# Spring Lane and Ellis Yard Development

Stage 1 – Road Safety Audit

Cork City Council

June 2023

**Figure 2-6 – Entrance to site.**

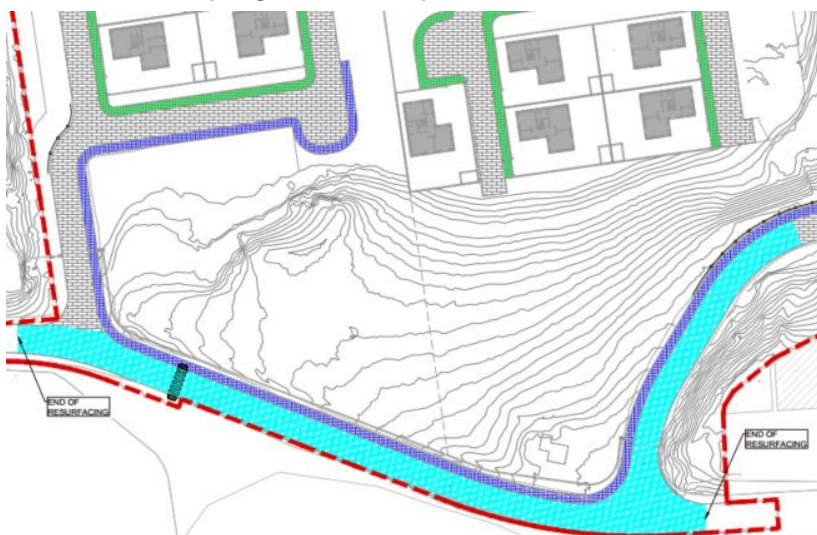
There are two proposed entrances to the development from the Ballyvolane Road. While on site a number of vehicles were observed to be travelling on this road at speeds which appeared to be greater than the posted speed limits. High speeds increase the risk of collision with vehicles exiting the Ellis' Yard / Spring Lane development.

The risk of collisions at the entrances to the site should be mitigated by ensuring maximum possible sightlines are provided. Also, consideration should be given to the provision of speed control measures as party of the resurfacing of Ballyvolane Road.

Figure 2-8 – Proposed Crossing Location.

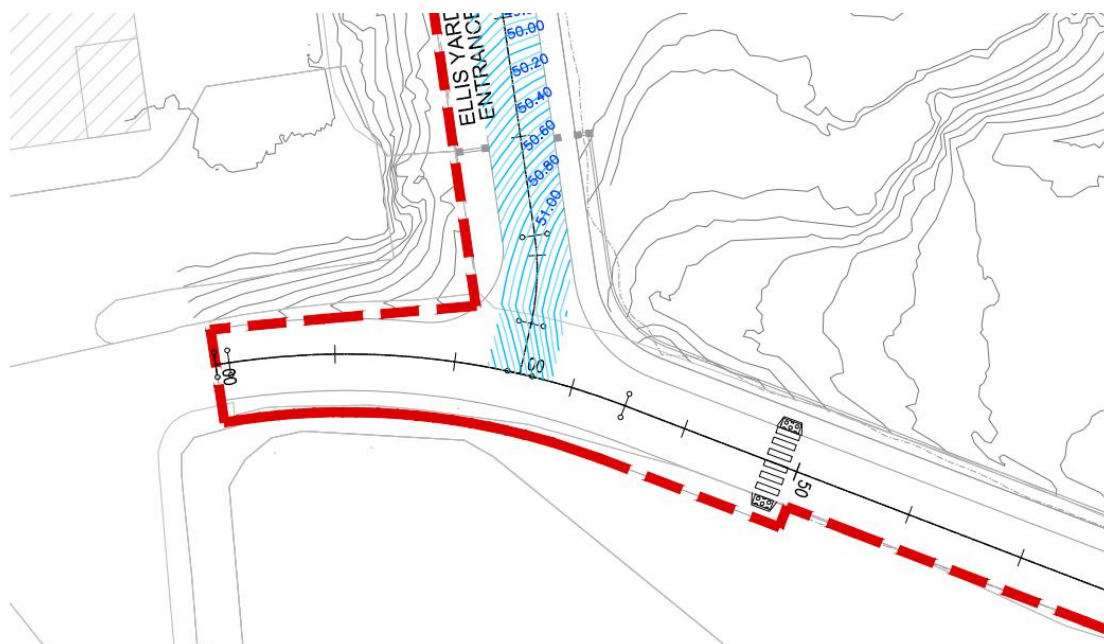
The design drawings indicate a proposed dropped kerb and tactile paving arrangement near the Ellis’s Yard entrance, at the southeast of the site. However, there is no existing footpath on the south side of the Ballyvolane Road to receive this proposed crossing facility. Further to this, the location of this crossing facility fails to provide the most direct desire line for pedestrians exiting the Ellis’s Yard site. Both of these issues may expose a pedestrian, particularly those with mobility impairments, to a potential collision with vehicular traffic.

The existing footpath on the south side of the Ballyvolane Road should be extended to facilitate the crossing facility. The location of the crossing facility should be reviewed.

**Figure 2-9 – Wide Corner Radius**

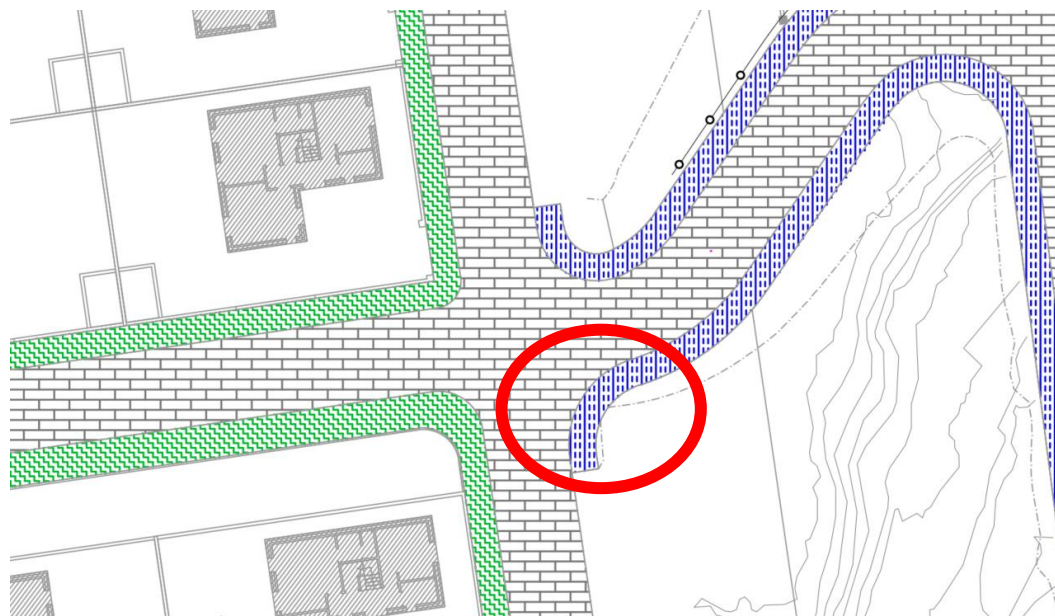
Throughout parts of the scheme, some of the corner radii appear wide. Wide corner radii enable vehicles to take the corners at higher speed, and also reduces intervisibility between crossing pedestrians and drivers which could result in collisions with pedestrians.

Check the corner radii throughout the scheme and where appropriate the wide corner radii should be reduced.
